DATE: July 1, 2022
TO: Allison Kennedy (Blaine County Land Use and Building Services)
Blaine County Planning and Zoning Commissioners
FROM: Samantha Stahlnecker (Opal Engineering, PLLC)
SUBJECT: Quigley Ranch Subdivision- Responses to Commissioner Questions

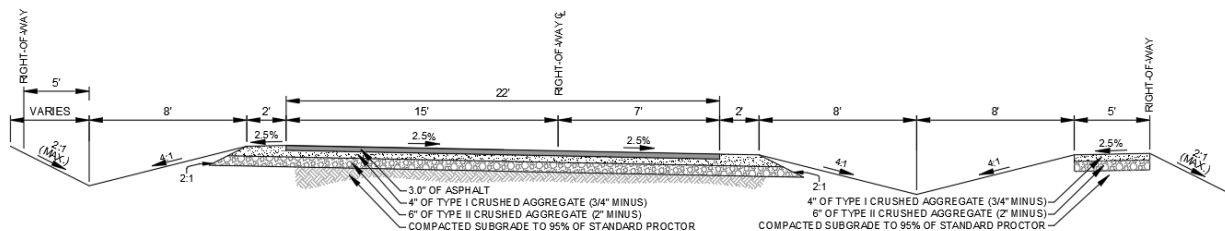
4. I need to know how the developer will ensure continued access to the groomed snowmobile trail by snowmobiles who are allowed to legally drive city streets to get to a trailhead. Moving the snowmobile trailhead further east might not work for wildlife and residents etc. in winter. *Providing winter parking east of the proposed lots on Quigley Road is the only way for snowmobiles to park and access the unpaved portion of Quigley Road. The current proposed parking location is compatible with proposed residential use. For recreators accessing Quigley Road via snowmobile, they would have to utilize the paved portion of Quigley Road like any other improved and maintained street in the city or county (riding on un-plowed portions of the right-of-way). The applicant/ HOA will not prohibit snowmobiles from accessing Quigley Road.*
